project: **SOP 53 2** FIGTREE DRIVE <u>SYDNEY OLYMPIC PARK</u> Copyright of the design and other information shown here is owned by Mirvac Design pty. Itd. Reproduction or use of the design by any party for any purpose is expressly forbidden without the written permission of Mirvac Design pty. Itd. Mirvac Design Nominated Architect Diana Sarcasmo NSW: 6525, VIC:19056, OLD: 5091, WA: 2982

# COVER SHEET

Modification to SSD 7662

### MODIFICATION TO SSD 7662

drawing no: DA-2134

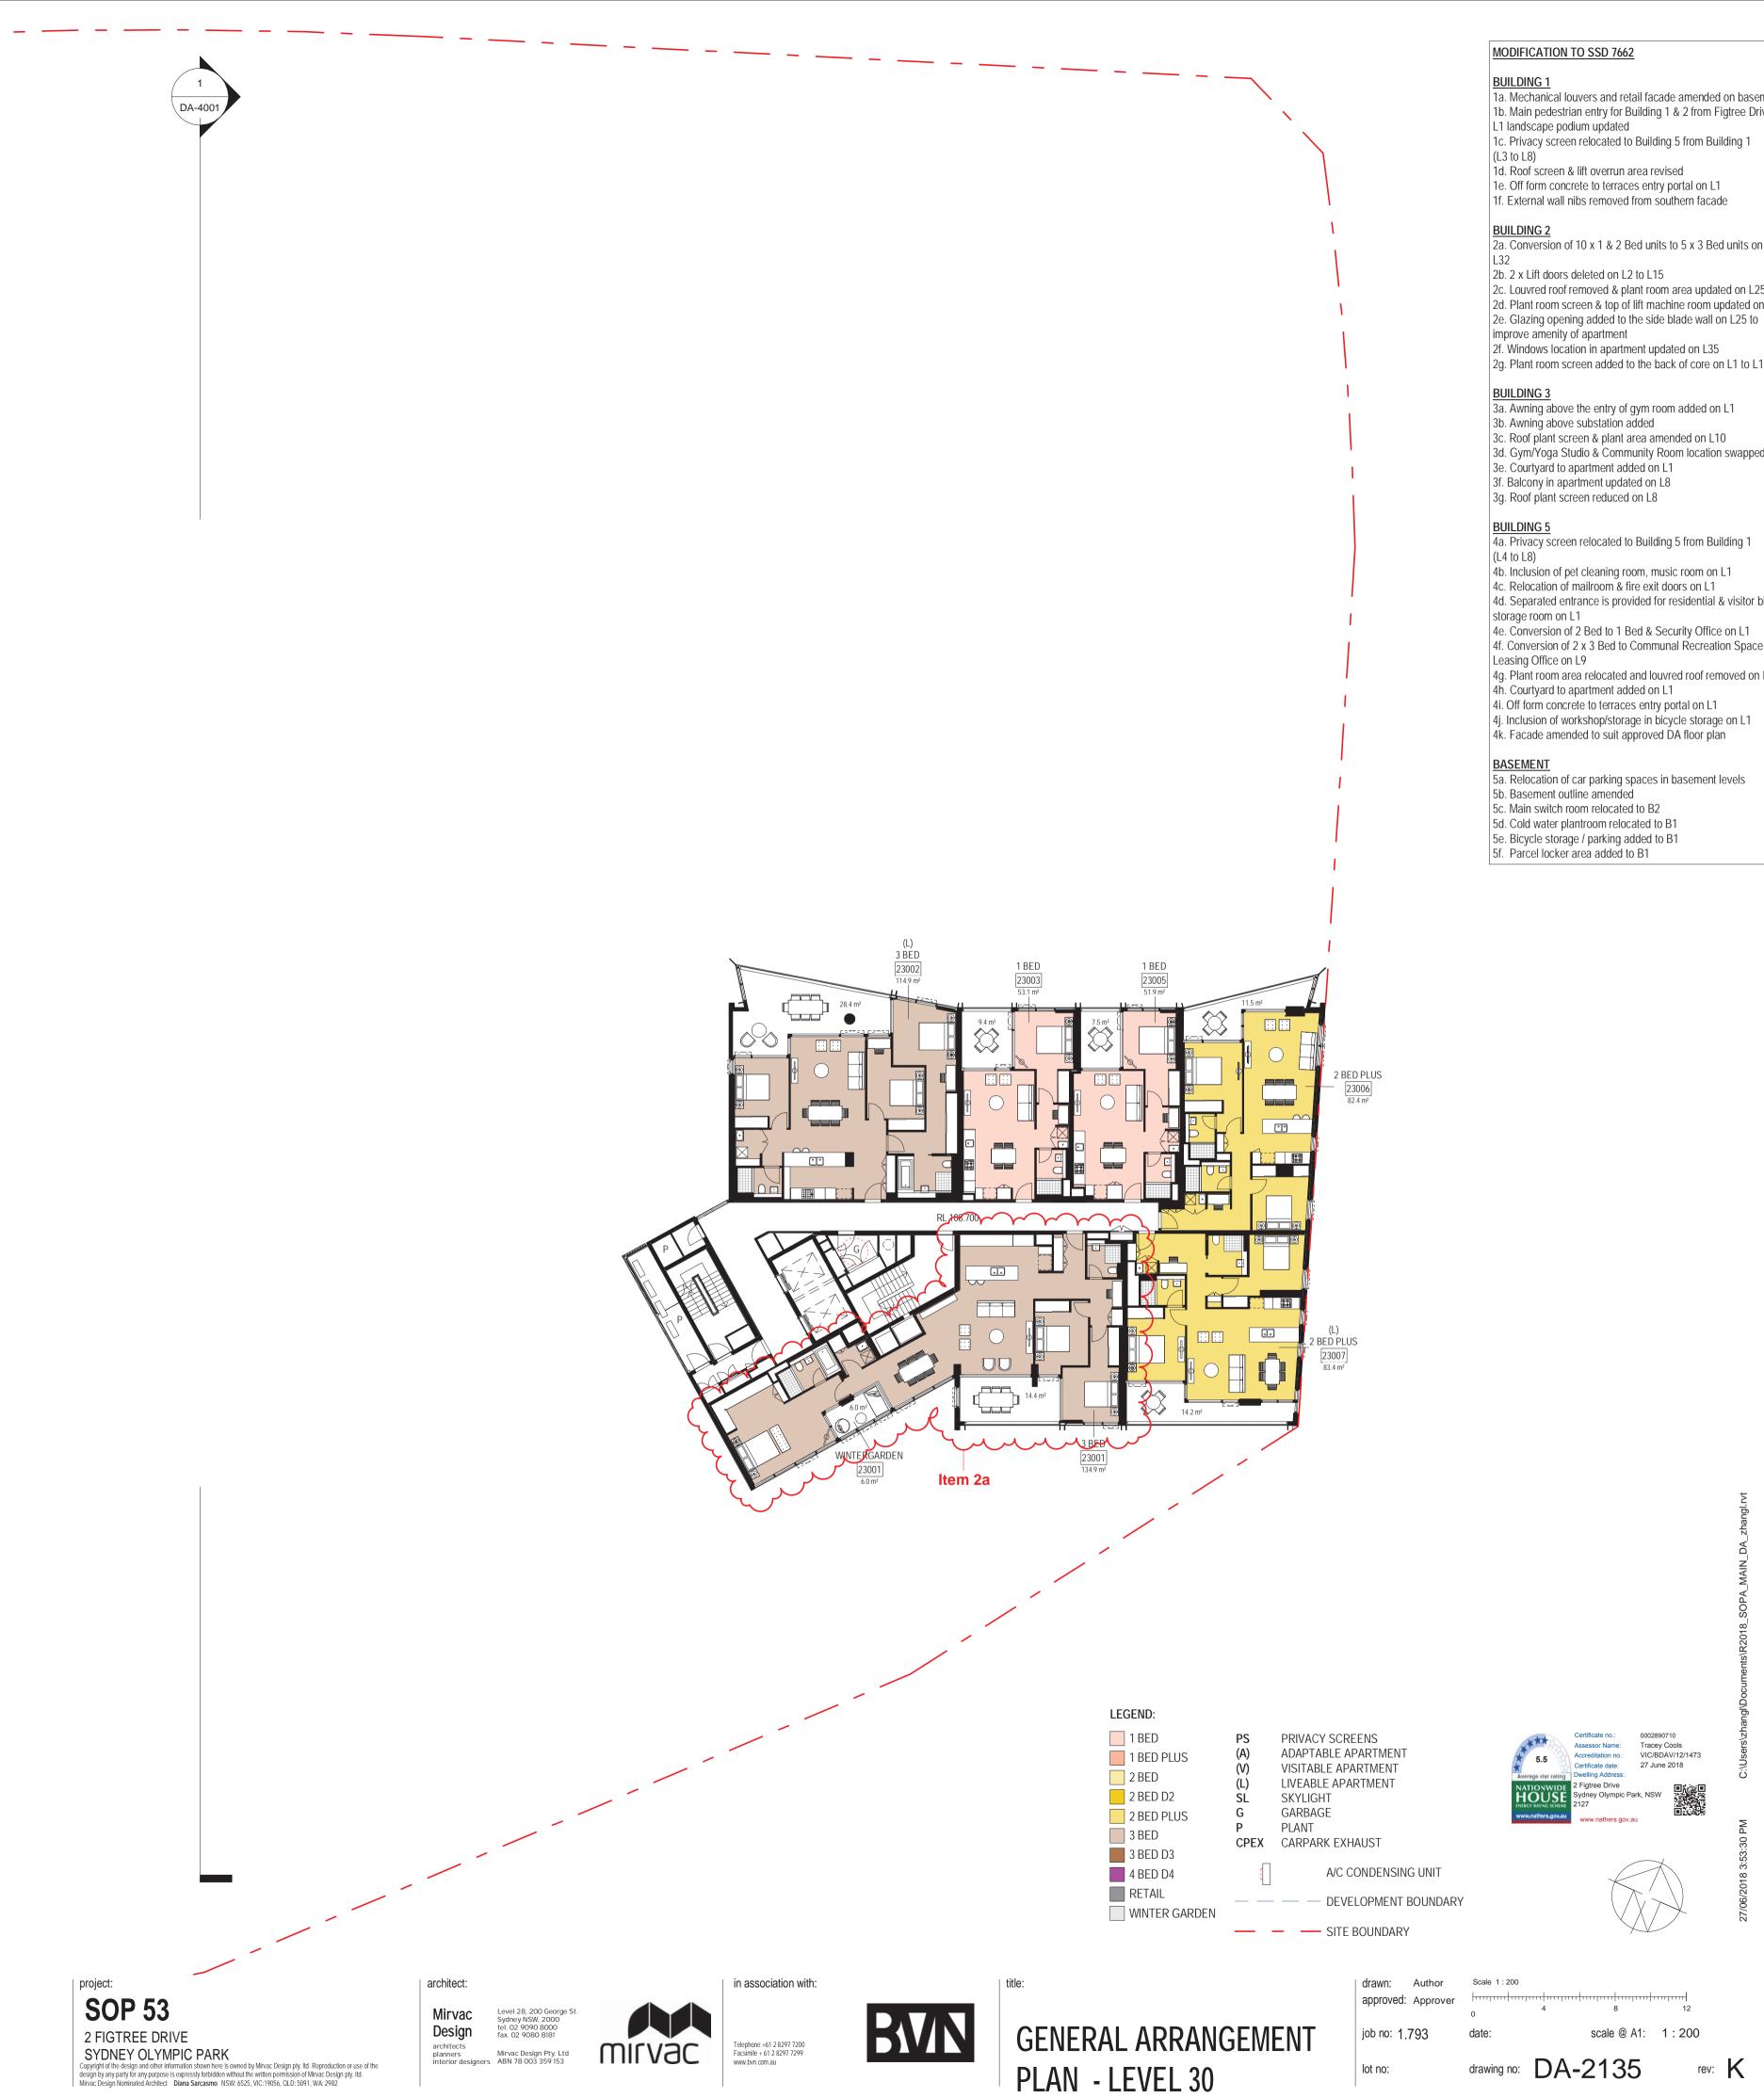
- 1a. Mechanical louvers and retail facade amended on basement 1 1b. Main pedestrian entry for Building 1 & 2 from Figtree Drive to
- L1 landscape podium updated 1c. Privacy screen relocated to Building 5 from Building 1
- (L3 to L8)
- 1d. Roof screen & lift overrun area revised
- 1e. Off form concrete to terraces entry portal on L1 1f. External wall nibs removed from southern facade

2c. Louvred roof removed & plant room area updated on L25 2d. Plant room screen & top of lift machine room updated on L36

- 2e. Glazing opening added to the side blade wall on L25 to improve amenity of apartment
- 2f. Windows location in apartment updated on L35

2g. Plant room screen added to the back of core on L1 to L16

- 3a. Awning above the entry of gym room added on L1 3b. Awning above substation added
- 3c. Roof plant screen & plant area amended on L10
- 3d. Gym/Yoga Studio & Community Room location swapped on L1
- 3e. Courtyard to apartment added on L1 3f. Balcony in apartment updated on L8
- 3g. Roof plant screen reduced on L8

4g. Plant room area relocated and louvred roof removed on L25 4h. Courtyard to apartment added on L1

- 4i. Off form concrete to terraces entry portal on L1
- 4j. Inclusion of workshop/storage in bicycle storage on L1
- 4k. Facade amended to suit approved DA floor plan

Scale 1:200 4 8 scale @ A1: 1 : 1 drawing no: DA-3000 rev: K

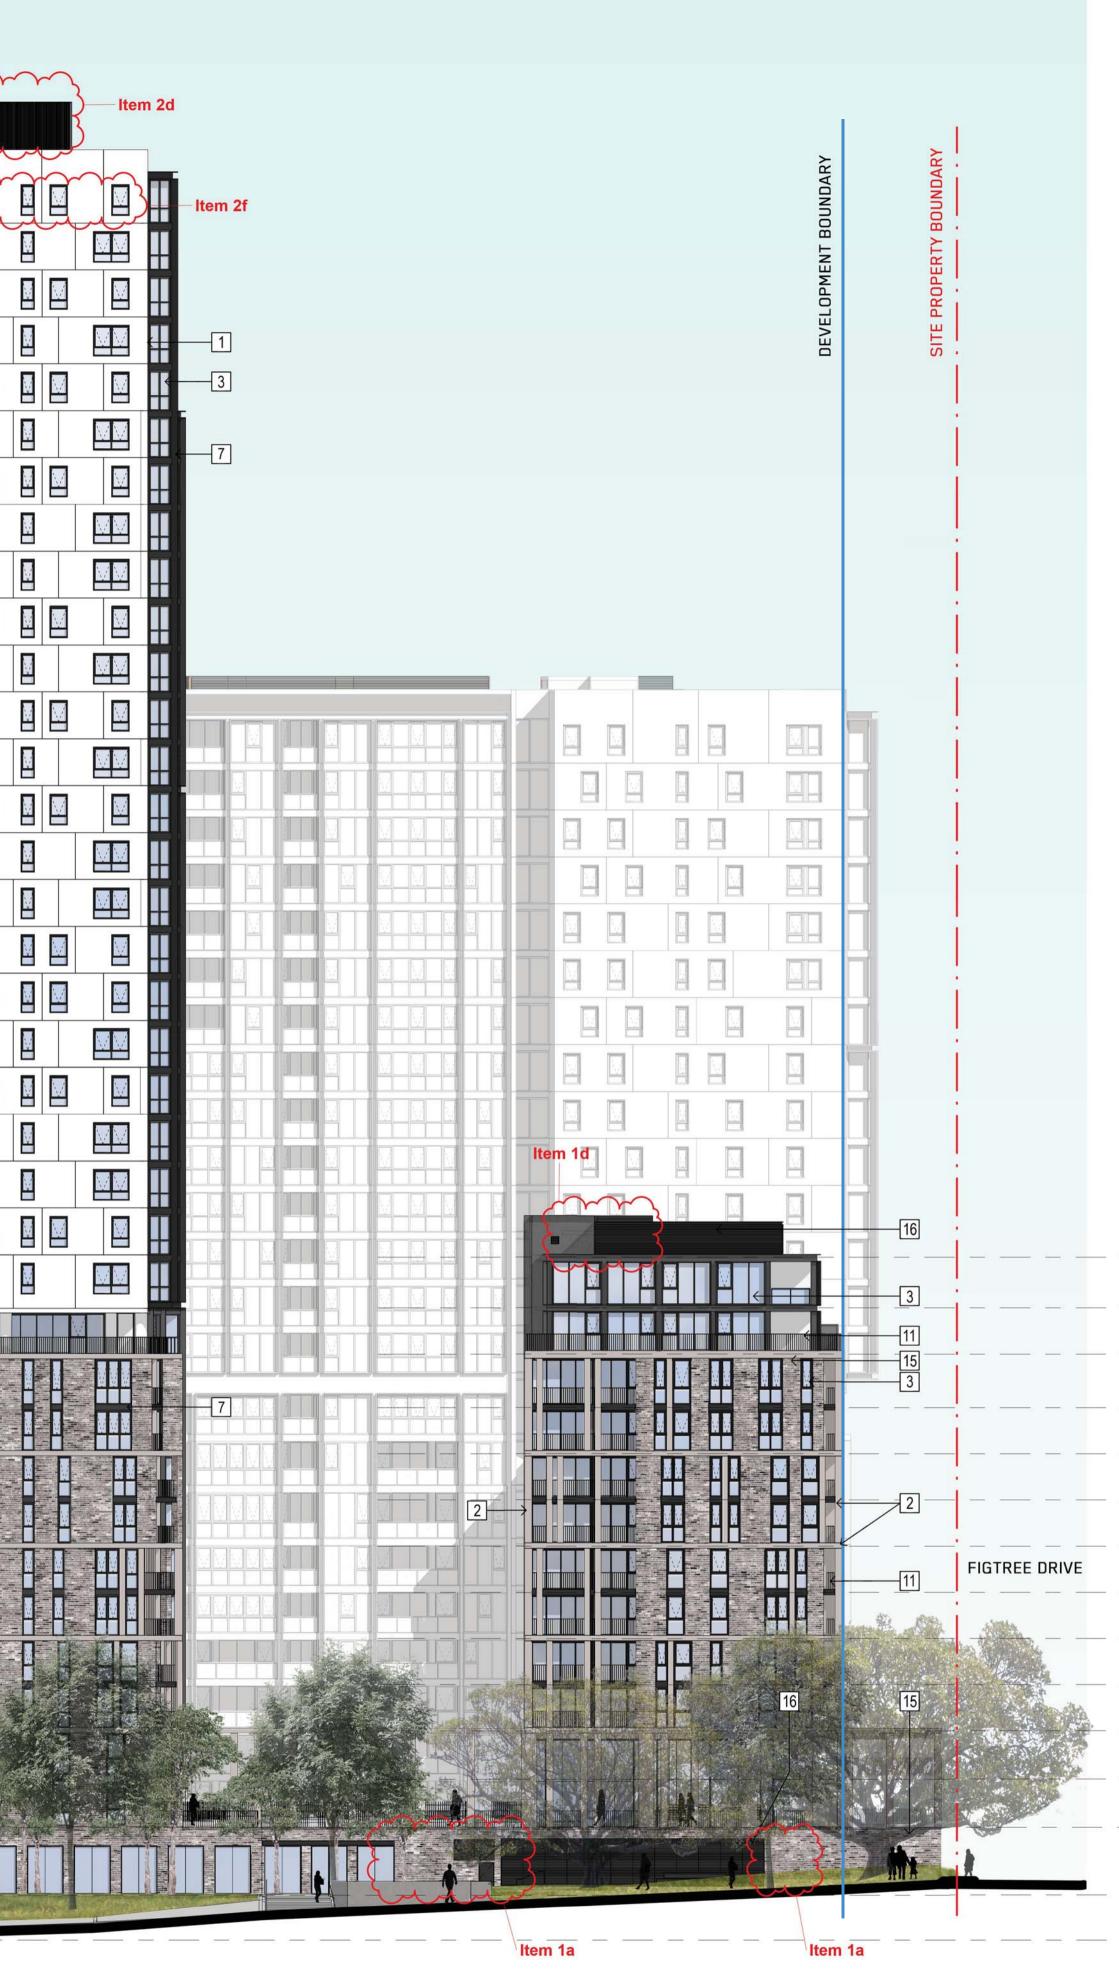
- 1a. Mechanical louvers and retail facade amended on basement 1 1b. Main pedestrian entry for Building 1 & 2 from Figtree Drive to
- L1 landscape podium updated 1c. Privacy screen relocated to Building 5 from Building 1
- (L3 to L8)
- 1d. Roof screen & lift overrun area revised
- 1e. Off form concrete to terraces entry portal on L1 1f. External wall nibs removed from southern facade

- 2a. Conversion of 10 x 1 & 2 Bed units to 5 x 3 Bed units on L28 to 1.32
- 2b. 2 x Lift doors deleted on L2 to L15
- 2c. Louvred roof removed & plant room area updated on L25
- 2d. Plant room screen & top of lift machine room updated on L36
- 2e. Glazing opening added to the side blade wall on L25 to improve amenity of apartment
- 2f. Conversion of 10 x 2 Bed to 1 Bed from L12 to L21
- 2g. Windows location in apartment updated on L35 2h. Plant room screen added to the back of core on L1 to L16

- 3a. Awning above the entry of gym room added on L1
- 3b. Awning above substation added 3c. Roof plant screen & plant area amended on L10
- 3d. Gym/Yoga Studio & Community Room location swapped on L1
- 3e. Courtyard to apartment added on L1
- 3f. Balcony in apartment updated on L8 3g. Roof plant screen reduced on L8

- 4h. Plant room area relocated and louvred roof removed on L25 4i. Courtyard to apartment added on L1
- 4j. Off form concrete to terraces entry portal on L1
- 4k. Inclusion of workshop in bicycle storage on L1
- 4I. Facade amended to suit approved DA floor plan

- 5a. Relocation of car parking spaces in basement levels
- 5b. Basement outline amended
- 5c. Main switch room relocated to B2
- 5d. Cold water plantroom relocated to B1 5e. Bicycle storage / parking added to B1
- 5f. Parcel locker area added to B1
  - 1 Light Coloured Masonry/Concrete Type 1
  - 2 Light Coloured Masonry/Concrete Type 2
  - 3 External Glazing System Type 1
  - 4 External Glazing System Type 2
  - 5 External Glazing System Type 3
  - 6 External Glazing System Type 4
  - 7 Metal Cladding Type 1
  - 8 Metal Cladding Type 2
  - 9 Metal Cladding Type 3
  - 10 Metal Cladding Type 4
  - 11 Metal Palisade Balustrade Type 1
  - 12 Metal Palisade Balustrade Type 2
  - 13 Metal Palisade Balustrade Type 3
  - 14 Metal Palisade Balustrade Type 4
  - 15 Brick Finish
  - 16 Plant Room Louvres
  - 17 Glazed Balustrade
  - 18 Off Form Concrete

EAST ELEVATION -**AUSTRALIA AVENUE**

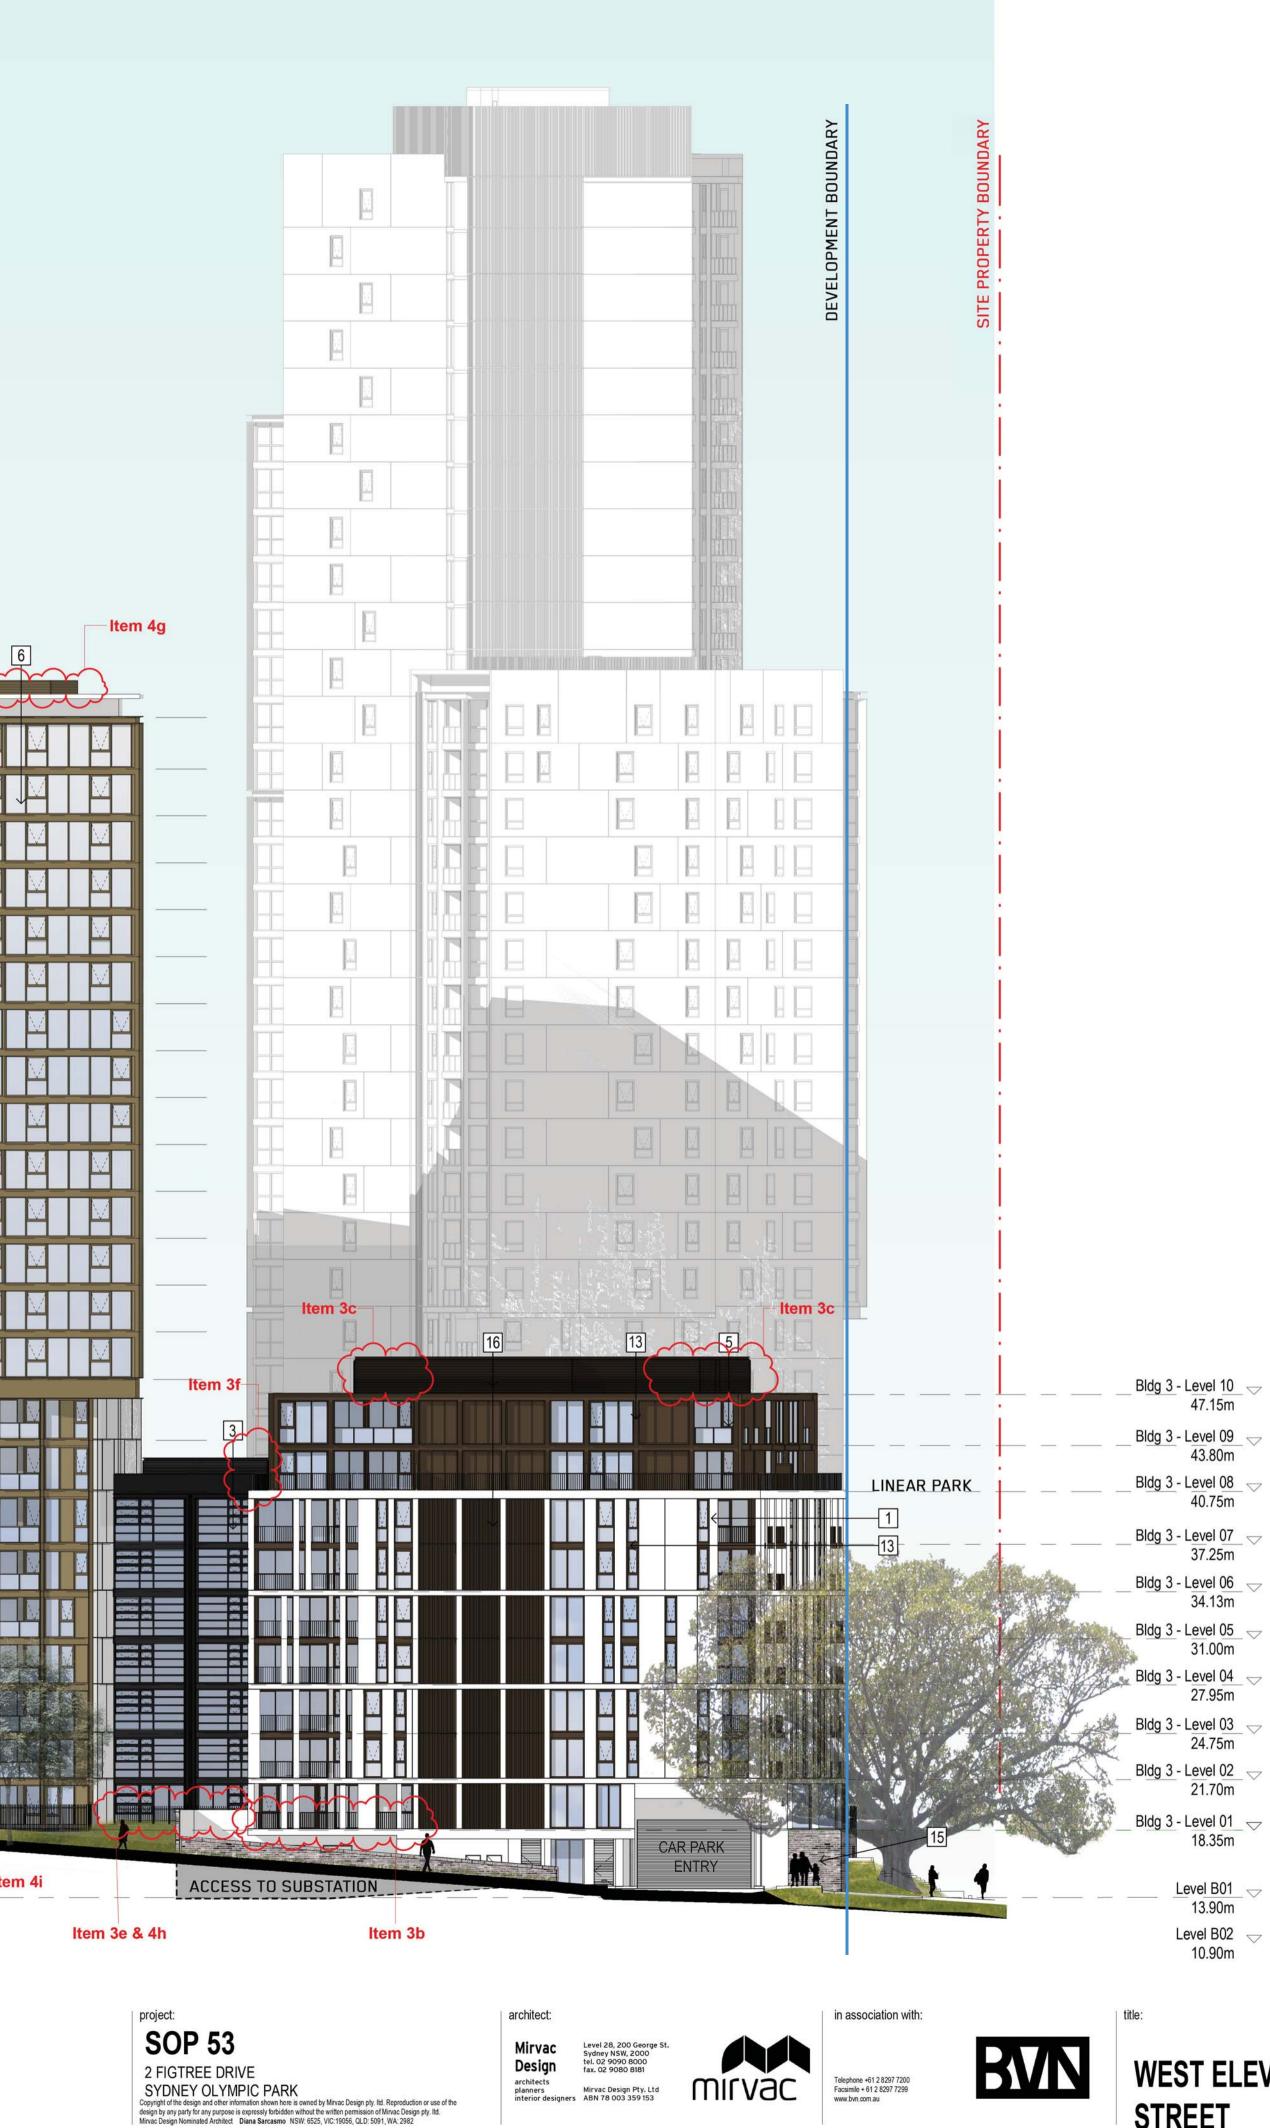
- 1a. Mechanical louvers and retail facade amended on basement 1 1b. Main pedestrian entry for Building 1 & 2 from Figtree Drive to
- L1 landscape podium updated
- 1c. Privacy screen relocated to Building 5 from Building 1
- (L3 to L8)
- 1d. Roof screen & lift overrun area revised
- 1e. Off form concrete to terraces entry portal on L1 1f. External wall nibs removed from southern facade

- 2a. Conversion of 10 x 1 & 2 Bed units to 5 x 3 Bed units on L28 to 132
- 2b. 2 x Lift doors deleted on L2 to L15
- 2c. Louvred roof removed & plant room area updated on L25 2d. Plant room screen & top of lift machine room updated on L36
- 2e. Glazing opening added to the side blade wall on L25 to
- improve amenity of apartment 2f. Windows location in apartment updated on L35
- 2g. Plant room screen added to the back of core on L1 to L16

- 3a. Awning above the entry of gym room added on L1 3b. Awning above substation added
- 3c. Roof plant screen & plant area amended on L10
- 3d. Gym/Yoga Studio & Community Room location swapped on L1
- 3e. Courtyard to apartment added on L1 3f. Balcony in apartment updated on L8
- 3g. Roof plant screen reduced on L8

4g. Plant room area relocated and louvred roof removed on L25 4h. Courtyard to apartment added on L1

- 4i. Off form concrete to terraces entry portal on L1
- 4j. Inclusion of workshop in bicycle storage on L1 4k. Facade amended to suit approved DA floor plan

- 5a. Relocation of car parking spaces in basement levels
- 5b. Basement outline amended
- 5c. Main switch room relocated to B2
- 5d. Cold water plantroom relocated to B1
- 5e. Bicycle storage / parking added to B1 5f. Parcel locker area added to B1
  - 1 Light Coloured Masonry/Concrete Type 1
  - 2 Light Coloured Masonry/Concrete Type 2
  - 3 External Glazing System Type 1
  - 4 External Glazing System Type 2
  - 5 External Glazing System Type 3
  - 6 External Glazing System Type 4
  - 7 Metal Cladding Type 1
  - 8 Metal Cladding Type 2
  - 9 Metal Cladding Type 3
  - 10 Metal Cladding Type 4
  - 11 Metal Palisade Balustrade Type 1
  - 12 Metal Palisade Balustrade Type 2
  - 13 Metal Palisade Balustrade Type 3
  - 14 Metal Palisade Balustrade Type 4
  - 15 Brick Finish
  - 16 Plant Room Louvres
  - 17 Glazed Balustrade
  - 18 Off Form Concrete
